Reference: 21.185r03v01

3 June 2022

Re: St Aloysius – Rozelle Campus
Response to Request for Information

Figure 3: Swept paths - bollard and kerb. Source: Google

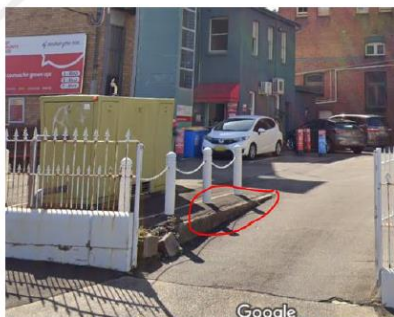
- ii) As shown in Figure 2 below, the swept path also details that the shuttle bus will impact a bollard protecting the electricity substation and drops off the edge of the kerb shown circled in red (Figure 3). Further investigation should be undertaken to explore whether there is scope to set the kerb back and to relocate the bollard to allow for better manoeuvrability of the shuttle bus.

- i) The updated swept path in the latest TAIA report (Ref: 21.185r01v07 dated 3 June 2022) shows that there is sufficient width of the driveway to accommodate both the body of the vehicle and the 300mm clearance on either side of the vehicle (red line) which meets the requirements of AS 2890.2 (2018).
- ii) The swept path analysis has been amended and is presented in the latest TAIA. This updated swept path analysis shows that the shuttle bus can manoeuvre clear of the bollards.
